Subject: **Response to Portion of NRC Request for Additional Information Letter No. 43 Related to ESBWR Design Certification Application - ESBWR Probabilistic Risk Assessment - RAI Numbers 19.1-11, 19.1-12, 19.1-19, 19.2-7, 19.2-25, 19.2-32, and 19.2-36**

**Enclosure 2**

**ESBWR Probabilistic Risk Assessment**

**RAI Numbers 19.1-11, 19.1-12, 19.1-19, 19.2-7,  
19.2-25, 19.2-32, and 19.2-36**

**Figure 1.** Isometric drawings of the BiMAC piping system. For the near-edge channels in the detailed design the connection will be to rectangular vertical channels shaped so as to cover the wall completely.

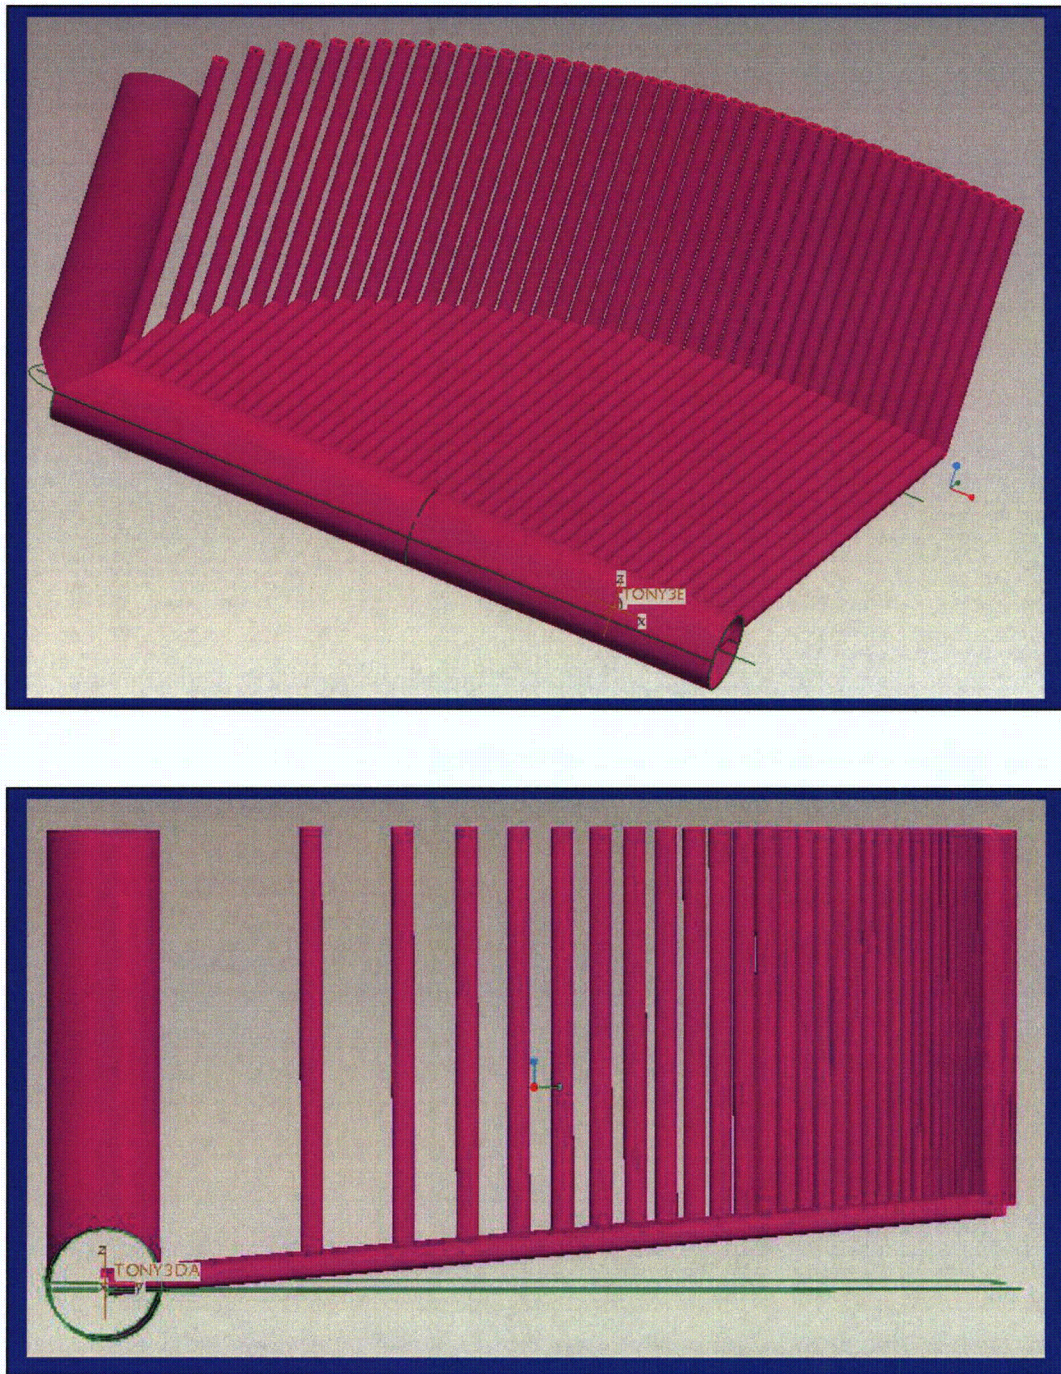
*Provide additional information regarding the BiMAC cooling jacket arrangement in the vicinity of the two sumps in the lower drywell floor, which the BiMAC is designed to protect, and the wall/floor area adjacent to the downcomer/deluge lines and nearedge channels. Include an overlay of PRA Figures 21.5.2-1c and e, and an isometric drawing. Discuss how the BiMAC piping in these two areas was treated in the computational fluid dynamic (CFD) simulations. Discuss whether asymmetries in these areas and the protection of the wall/floor area adjacent to the downcomer/deluge lines by only a limited number of near-edge channels can introduce the potential for steam starvation and local burnout, particularly since the maximum heat flux occurs near the intersection of the horizontal and riser pipes (as shown in Figure 21.5.4.3-1b).*

Isometric drawings are shown below in Figure 1.

The piping arrangement will be such that the sumps will be at the far end of the central (longest) channels. The sumps will be shaped so as to “form” around the pedestal walls with a minimal side exposure. A specially shaped piping jacket in the detailed design will provide coverage of this limited side area of the sumps. Table 21.5.4.3.1 of NEDO-33201 Rev 1 Section 21 shows that the whole quantity of core debris and 160 tons of metals all in molten state would be needed to begin to cover the vertical portion of the central channels at this location. Thus there are no issues about the CFD modeling this area, and there are no issues about the sumps receiving significant thermal loads in this design. The sidewall coverage was put in the design to provide extra margins of protection against asymmetries and potentially small thermal loads, which nevertheless would be good to have. To optimize the design in this respect we must wait for the BiMAC tests, so as to learn the (CHF) tolerance of the design to smaller pipe inclination angles, which will interact with the vertical positioning of the sumps on the floor, but this, given the tolerance to CHF, is normal engineering design practice best left for the COL stage.

Similarly, the near edge channels will need special consideration in the detailed design. Again, as Table 21.5.4.3.1 shows the vertical segments of these channels will be exposed to melt with the first quantities that arrive onto the BiMAC, and they will be exposed to thermal loads if any of these quantities remain molten for a sufficiently long time to deplete the sacrificial material that will be provided on these pipes. On modeling natural convection loads nothing special, beyond to what was done already, is needed, and yes the thermal loads are high locally (as explained in the report) but this is the area that is best protected against CHF, as we have learned from the ULPU experience. The reason is that the same mechanism that if present would produce the high thermal loads would also be responsible for thermally loading the vertical portions of the channels, thus driving strong natural circulation flows and thus making the CHF in the short, inclined channels such as for low quality, “forced convection flow. We expect the CHF in this location to be over 1,000 kw/m<sup>2</sup>, and this we will know for sure soon by BiMAC testing.

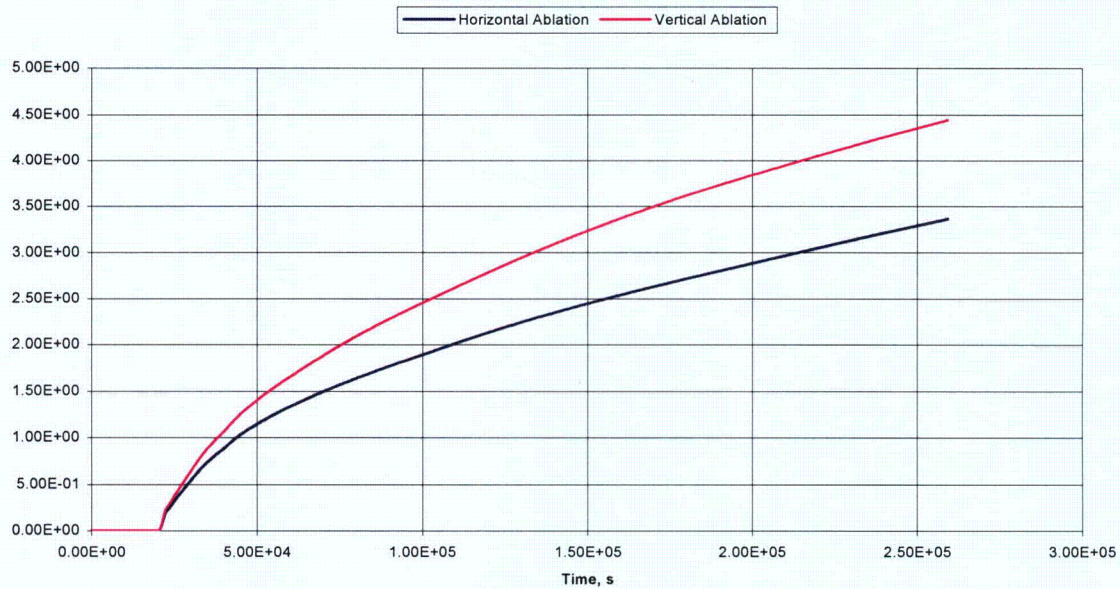
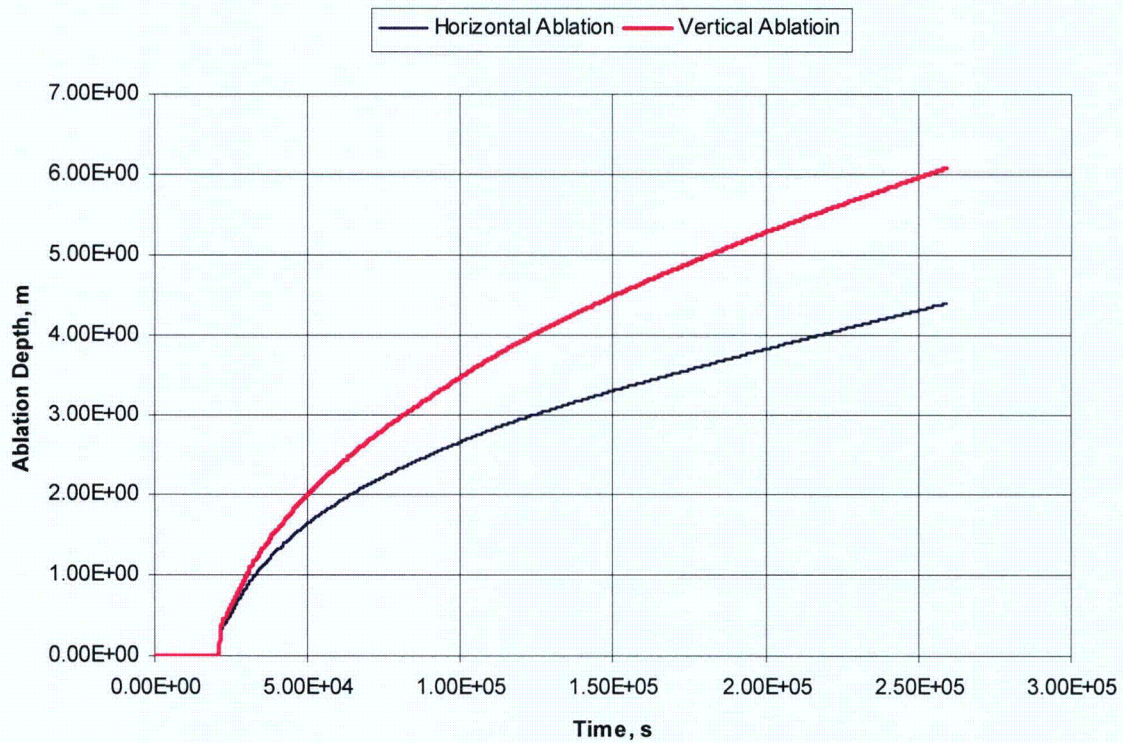
*Provide an assessment of the potential for RPV pedestal failure given failure of BiMAC and continued corium-concrete interaction (CCI). Provide plots of concrete ablation in the vertical and horizontal directions as a function of time for both limestone and basaltic concrete. Provide an assessment of whether the structural integrity of the reactor pedestal/RPV would be maintained under these conditions.*

Sensitivity studies using MAAP were performed to estimate concrete ablation for 3 cases with both limestone and basaltic concrete. These cases involved a loss of injection with successful depressurization of the RPV.

Since detailed structural analysis has not been completed for the ESBWR containment, the ABWR PRA was reviewed for insights into the probability of pedestal failure. The ABWR PRA determined that the lower limit for the amount of radial erosion, which can be sustained without pedestal structural failure, is 1.55 m of the 1.7 m pedestal wall thickness or 91%. This equates to 2.28 m of the 2.5 m ESBWR pedestal thickness.

1. dry (CCI) – deluge system does not actuate to flood lower drywell floor
2. minimum heat transfer between corium debris pool and overlying water pool – deluge system does flood lower drywell. MAAP parameter to influence heat transfer from the corium debris pool to overlying pool is set at lowest value in the suggested range.
3. default heat transfer between corium debris pool and overlying water pool – same as 2 except suggested default value is used.
4. heat transfer between corium debris pool and overlying water pool was controlled to obtain a heat transfer rate of 200kWt/m<sup>2</sup>.

The results are shown in the table below and the horizontal and vertical ablation plots for case 4 are shown below. Note that RPV failure occurs at approximately 20,000 seconds in the sensitivity cases.

Case	Time to Horizontal Ablation = 1.25m	Time to Horizontal Ablation = 2.5m
Basaltic Dry	35,287 s	83,417 s
Limestone Dry	46,973 s	146,593 s
Basaltic Min Heat Trnfr	57,842 s	166,681 s
Limestone Min Heat Trnfr	58,185 s	161,015 s
Basaltic Default Ht Trnfr	Max ablation = 0.32 m	N/a
Limestone Min Heat Trnfr	Max ablation = 0.23 m	N/a
Basaltic Controlled Ht Tfr	38,989 s	90,873 s
Limestone Controlled Ht Tfr	55,405 s	155,729 s
